SERVICE BULLETIN

BULLETIN NO: SBUS000148-26

TITLE: 6700 OPERATION MANUAL UPDATE

PRODUCT SERIES / MODEL: 6700 SJ2

Figure 2.2.10-3
REAR BRAKE ADJUSTMENT

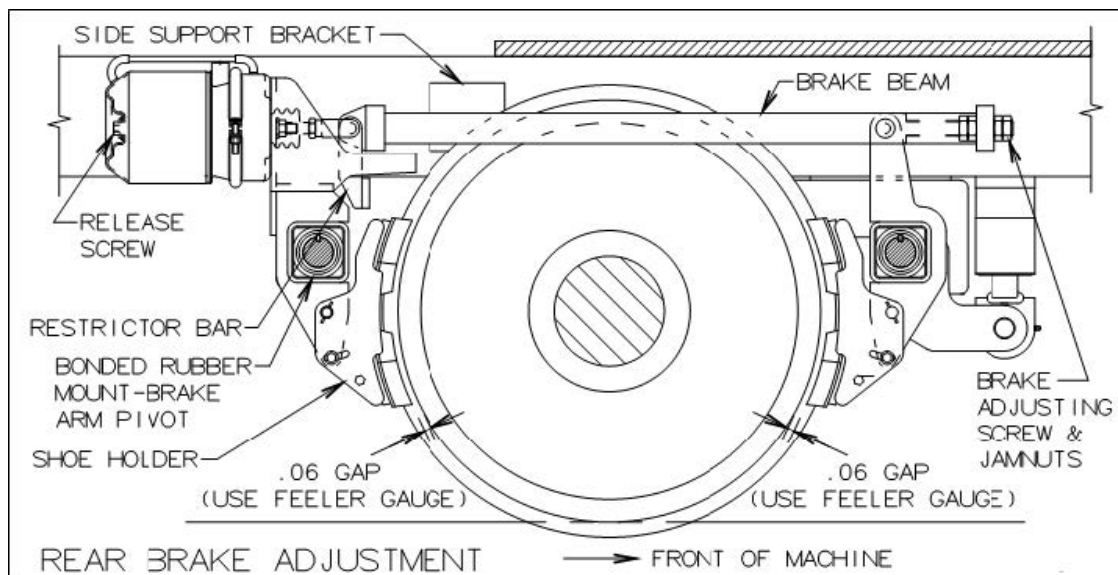
The rear service brake shoe adjustment procedure in the Operator's Manual contains an incorrect clearance in the description.

Improper adjustment may result in slow / weak rear brake response.

Replace sheet 200 of the operator's manual (part number 5083236) with the revised sheet attached to this Service Bulletin.

Ensure that the rear brake shoe clearance is adjusted to the correct specification of 1/16" in accordance with the revised instructions.

1. Retract the spring applied parking brakes using machine air system pressure.
2. For safety, turn the release bolt counterclockwise (use 3/4"/19 mm socket) until the slack is taken up and bolt is holding rod in position. Check for security by releasing air pressure.
3. Approximately 1/16"/2 mm gap is desired between brake shoe and the wheel surface. The gap is achieved by adjusting the slack adjusters with air brake chamber.
4. Reapply air pressure to the spring port (retracting brakes) by pulling round parking brake knob on right-hand side of cab (push diamond-shaped knob). Make sure air system is at full pressure (90-110 PSI/6.2- 7.6 bar). Turn release bolt clockwise until it is tight (35-45 ft-lbs./47 61 Nm). Check gap to make sure 1/16"/2 mm gap has been maintained.
